PROJECT: King Street Church (Project No. 1526)
Chambersburg, Pennsylvania

DATE: March 30, 2016

ADDENDUM #3
(Clarifications and Revisions)

3.03 Sheet UC101 Utilities Coordination Plan (Revision #1 dated 03/29/16)

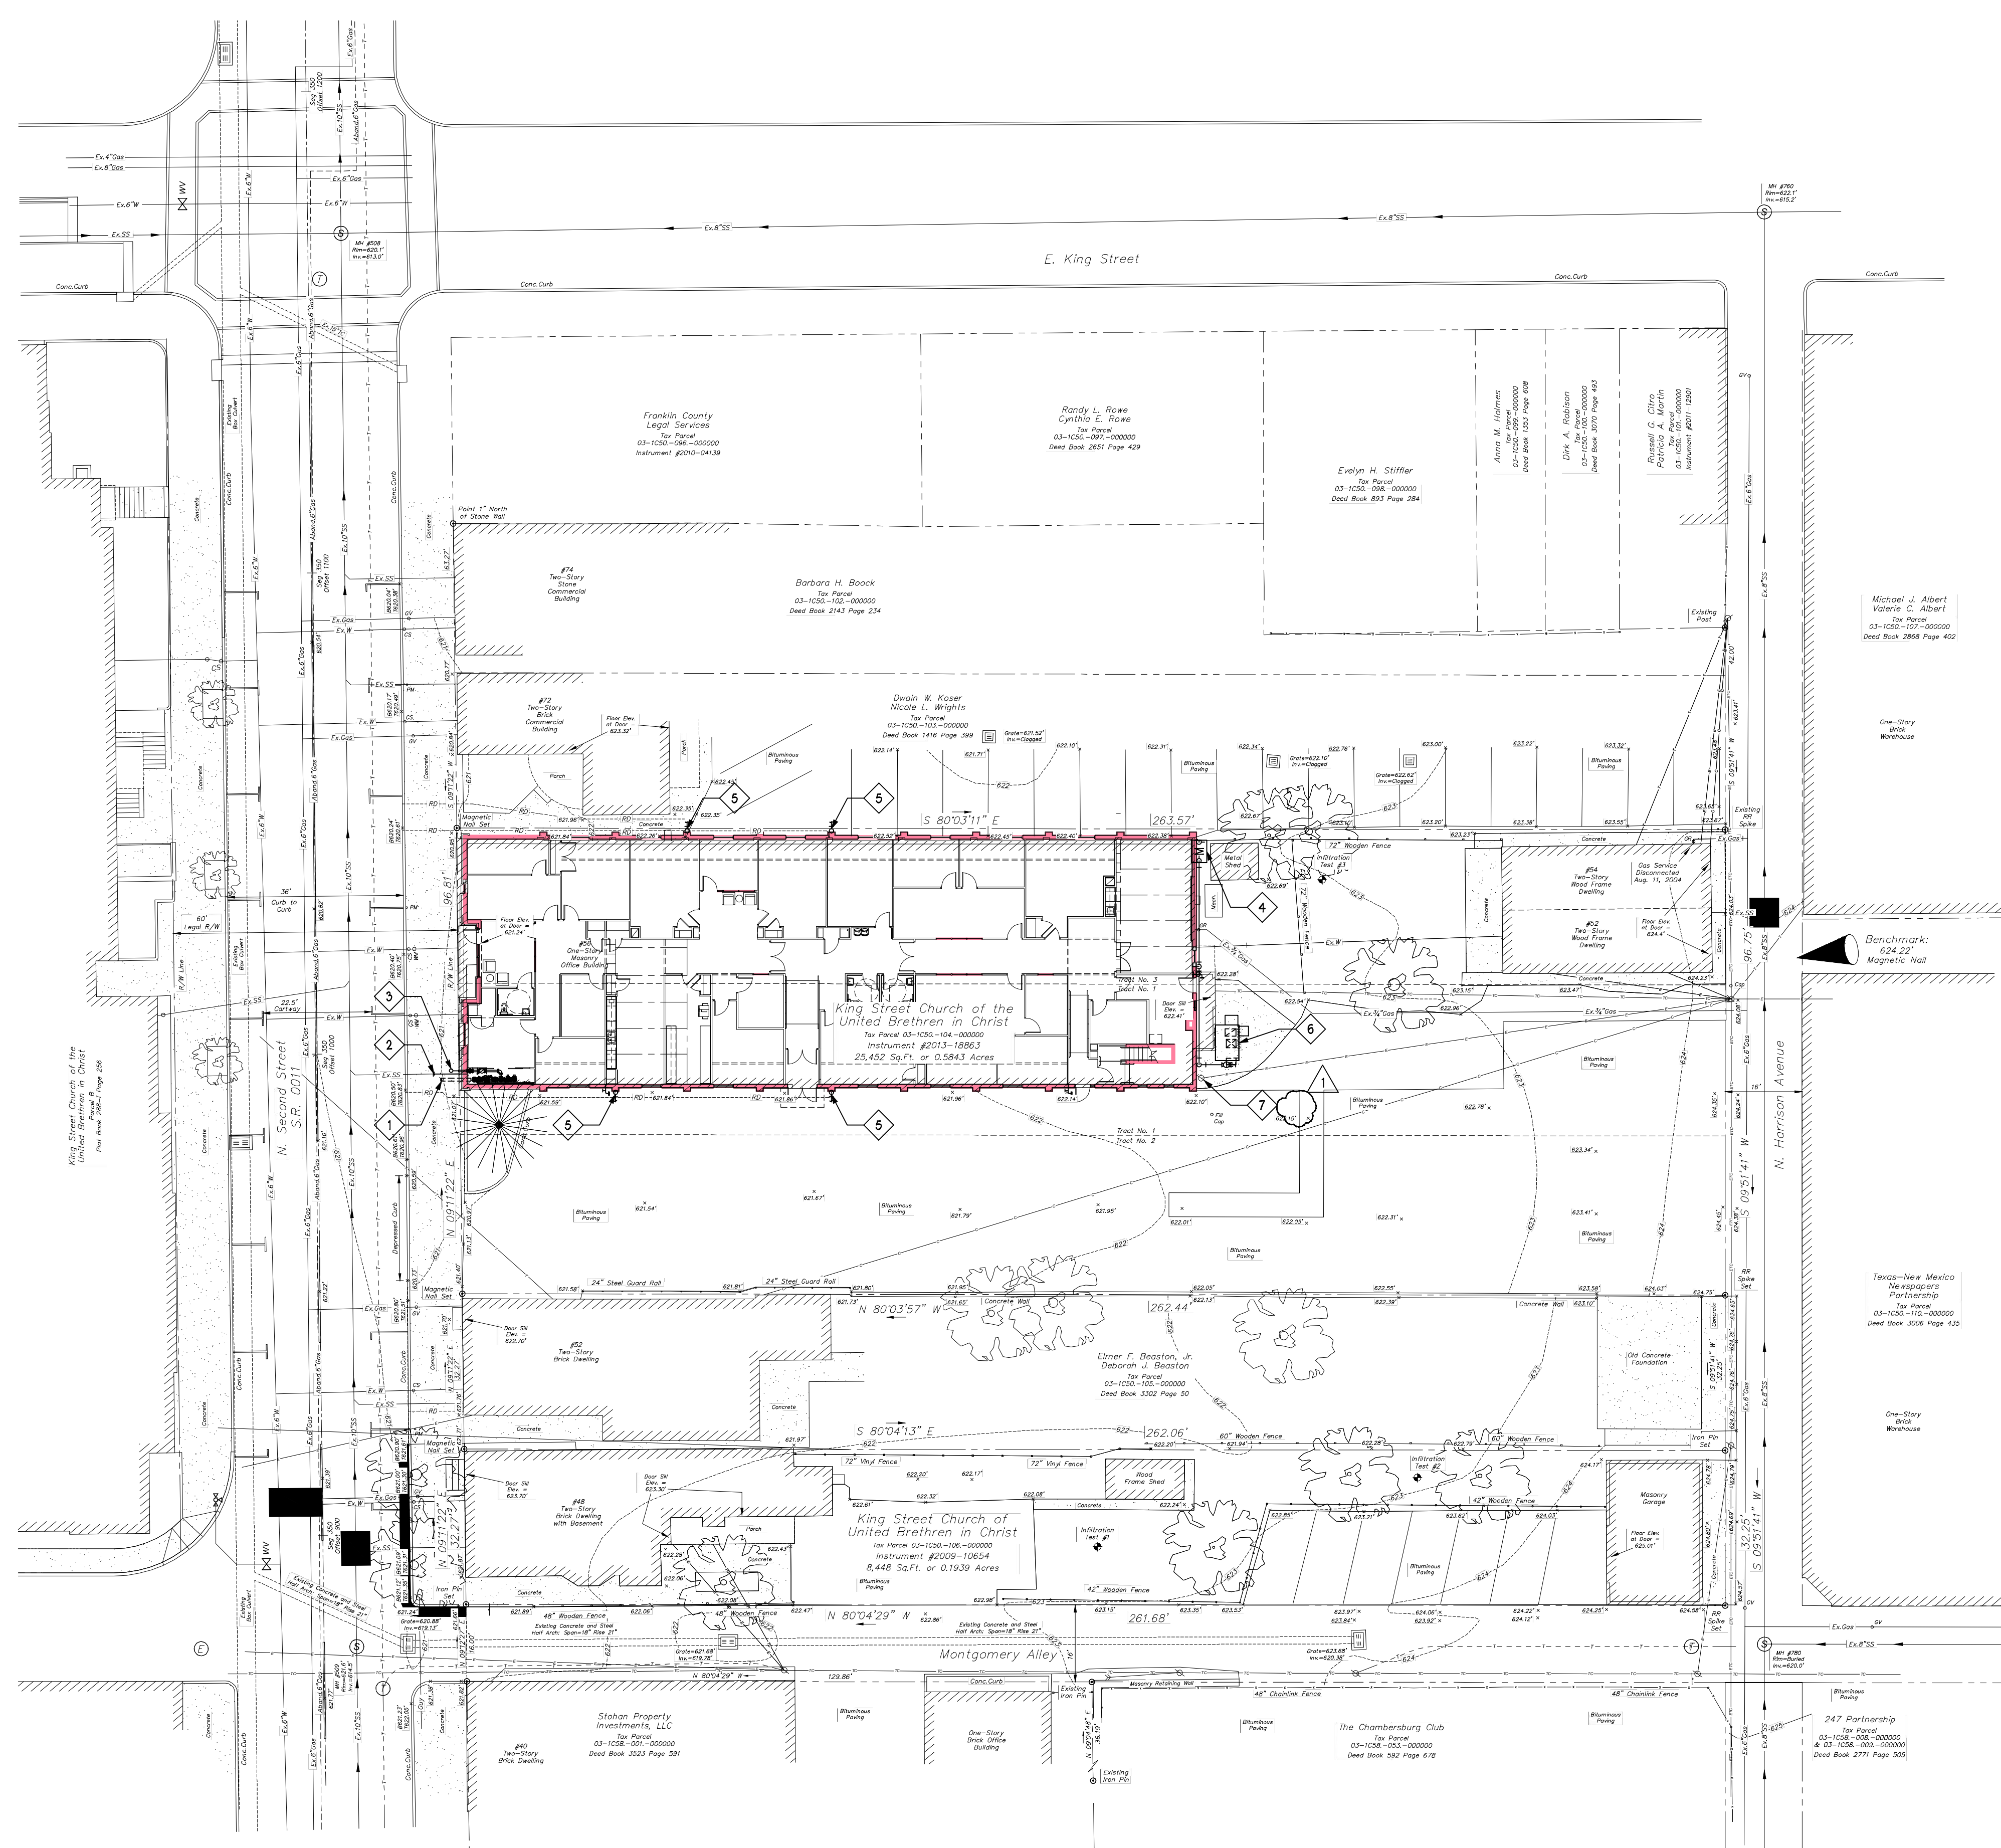
A. REVISE Sheet Keyed Notes

- NEW 6" COMBINATION FIRE PROTECTION AND DOMESTIC SUPPLY ENTRY.
- EXISTING 3" SANITARY BUILDING EXIT TO BE REUSED.
- FIRE DEPARTMENT 5" STORTZ CONNECTION. COORDINATE REQUIREMENTS WITH A.H.J.
- INSTALL NEW NATURAL GAS METER. FIELD VERIFY EXISTING NATURAL GAS POINT OF CONNECTION. COORDINATE REQUIREMENTS WITH A.H.J.
- CONNECT NEW DOWNSPOUT TO EXISTING TRANSITION TO EXISTING UNDERGROUND STORM WATER COLLECTION SYSTEM.
- NEW EXTERIOR MECHANICAL UNIT. REFER TO MECHANICAL PLANS.
- INSTALL NEW ELECTRICAL SERVICE BY EXTENDING EXISTING UNDERGROUND CONDUITS. REFER TO ADDITIONAL PLANS AND COORDINATE WITH LOCAL UTILITIES.

Site and Utility Plan
for
King Street Church Of the United Brethren In Christ
located in
Borough Of Chambersburg, Franklin County, PA

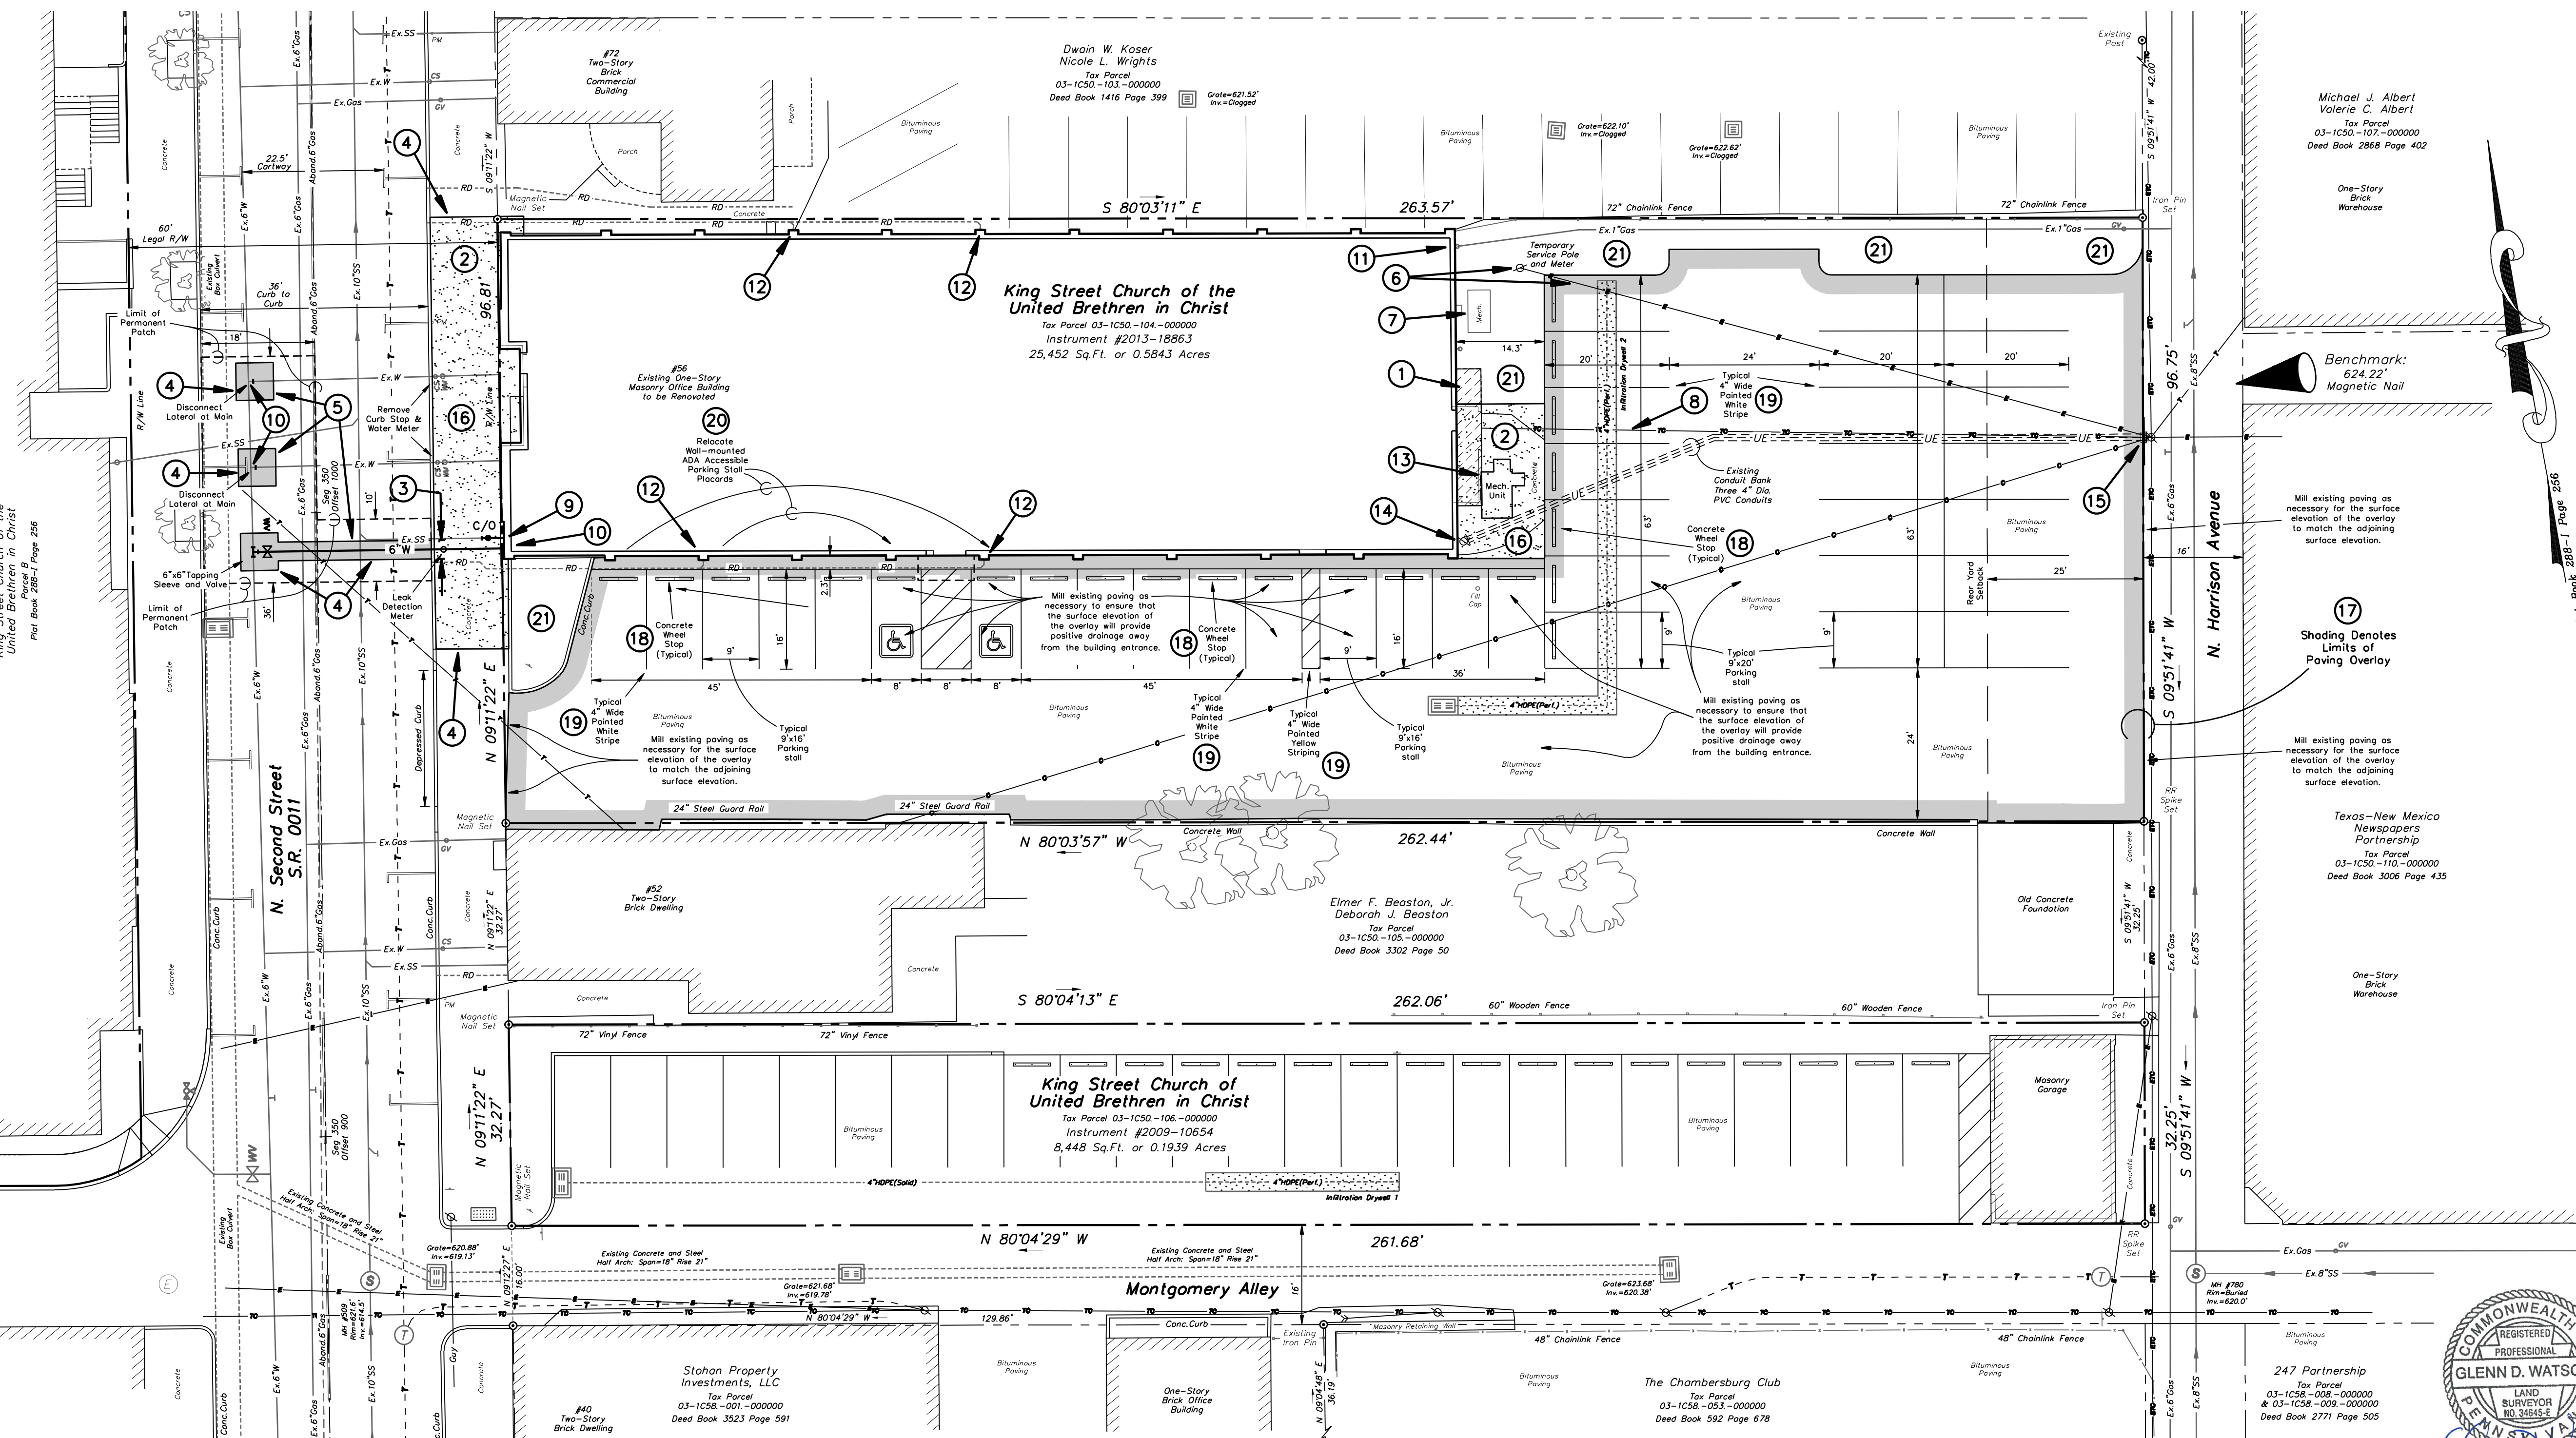
3.06 Site and Utility Plan (Revision dated 03/30/16)

A. REPLACE Entire Drawing Sheets 1 and 2

Sheet is reissued to reflect extent of Borough permanent paving patching. There is no change to temporary patching scope required by Contract. Sprinkler/water tap and disconnect work must be completed between September 12 and October 14, 2016. Contract requires temporary paving patch to be maintained per all Borough standards as necessary until the permanent patch is installed by the Borough in May, 2017.
